DCA/750XL/3A Wiring Loom Protective Sleeve – Inspection and Installation

Applicability: Model 750 XL aircraft, S/N 102 through to 134.

PACSB / XL / 009 Issue 2

INSPECTION – WIRING LOOM PROTECTIVE SLEEVE

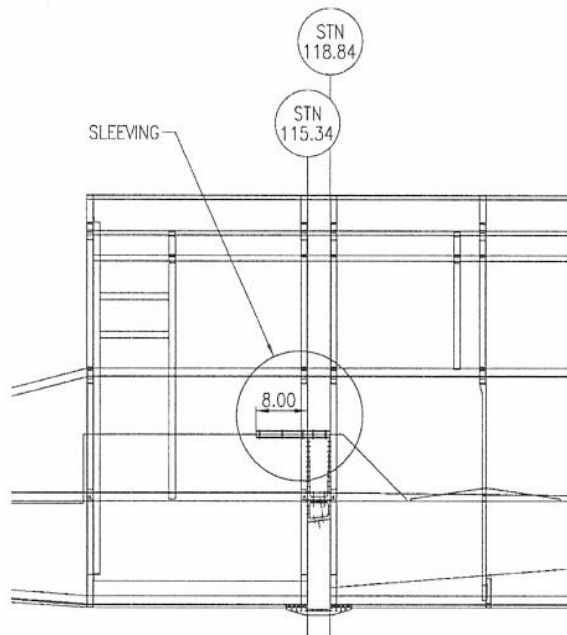
1. Remove the interior lining on the RHS of the fuselage above the wing spar. (Refer MM Ch 25, 25-10-00, page 401.)
2. Examine the loom as it passes the fuel vent lines adjacent to stations 115.34" and 118.84". There should be clearly visible, dark green or clear plastic sleeve wire-tied around the loom at these points. Refer illustration.

1. If sleeving is present, the longer sleeve will extend 8" forward of station 115.34", and the shorter (3.5") sleeve should fill the gap between the frames. If all is correct, reinstall the linings.
2. If missing, order part number SLE2-1-080S (8") and/or SLE2-1-035S sleeves from PAC spares. To install, position as indicated on the drawing excerpt, wrap around the loom and position as illustrated above. Wire-tie the sleeves as illustrated.
